Final Product/Process Change Notification

Document #:FPCN23658ZS1

Title of Change:	Update of FPCN23658ZS (Wafer fab transfer to onsemi Gresham, Oregon USA from onsemi Fab2, Oudenaarde, Belgium related to Fab2 sale) – Removed update of IOUT_VCC1 max value
Proposed Changed Material First Ship Date:	01 Sep 2022 or earlier if approved by customer
Current Material Last Order Date:	31 Mar 2022 #PD24322Z <i>Orders received after the Current Material Last Order Date expiration are to be considered as orders for new changed material as described in this PCN. Orders for current (unchanged) material after this date will be per mutual agreement and current material inventory availability.</i>
Current Material Last Delivery Date:	31 Aug 2022 <i>The Current Material Last Delivery Date may be subject to change based on build and depletion of the current (unchanged) material inventory</i>
Product Category:	Active components – Integrated circuits
Contact information:	Contact your local onsemi Sales Office or Jelle.Genne@onsemi.com

Figure 4. CAN Timing Parameters

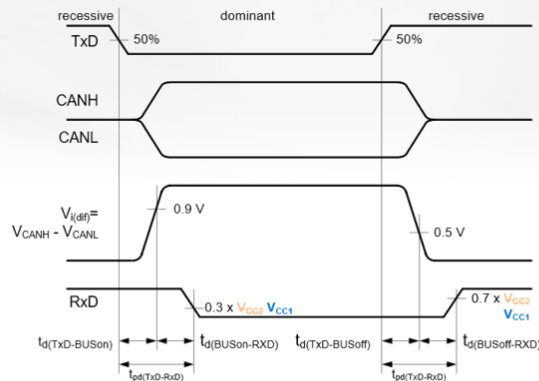
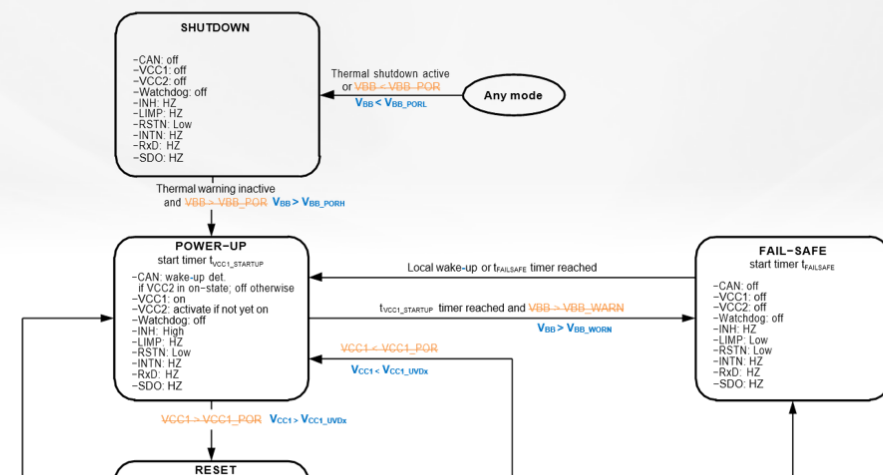
Figure 4 – CAN Timing parameters:

- Correct V_{CC2} to V_{CC1}

Figure 7. State Diagram of the Special Operating Modes – Flash Mode

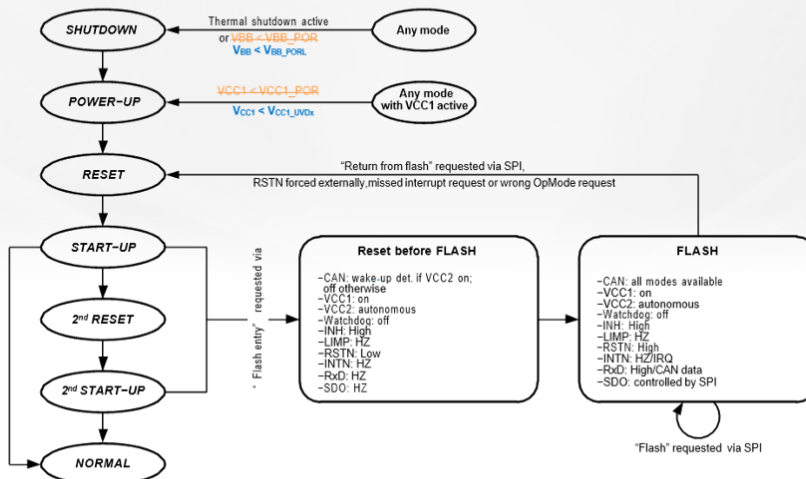
Figure 7 – State Diagram of the Special Operating Modes – Flash Mode:

- Refer to correct threshold levels / names | • Typo correction (wake-up -> wake-up)

Figure 8. State Diagram of the Special Operating Modes – Software Development and Factory Flashing mode

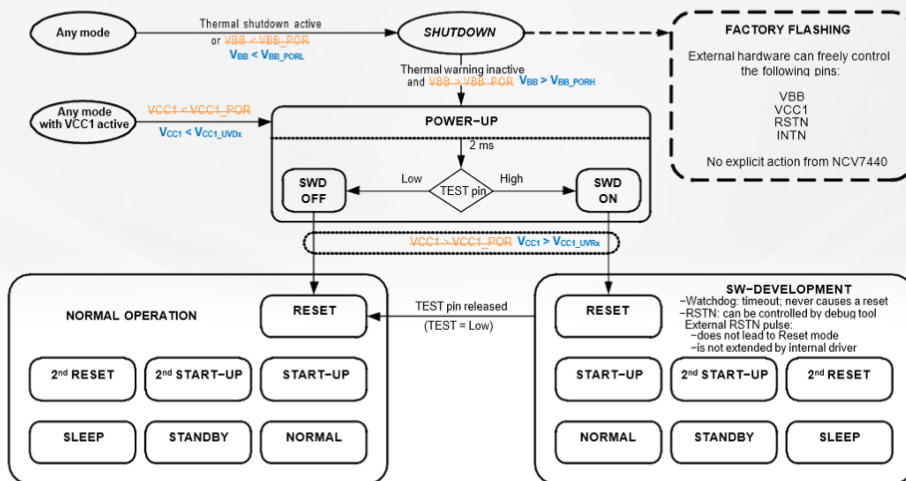
Figure 8 – State Diagram of the Special Operating Modes – Software Development and Factory Flashing mode:

- Refer to correct threshold levels / names

Figure 10. State Diagram of the V_{CC2} Regulator Control

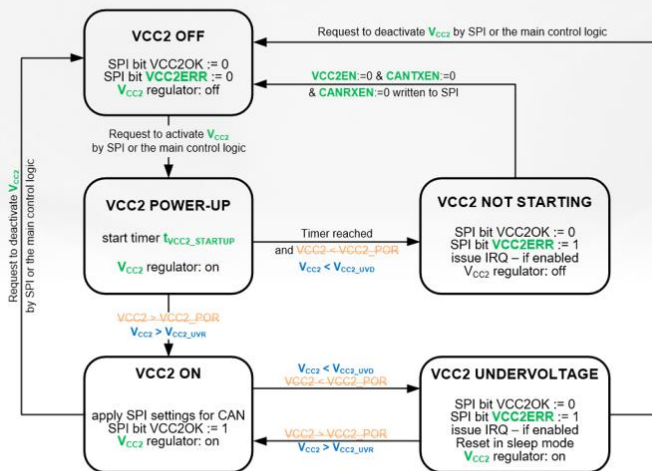
Figure 10 - State Diagram of the V_{CC2} Regulator Control:

- Refer to correct threshold levels / names | • Typo correction (in green)
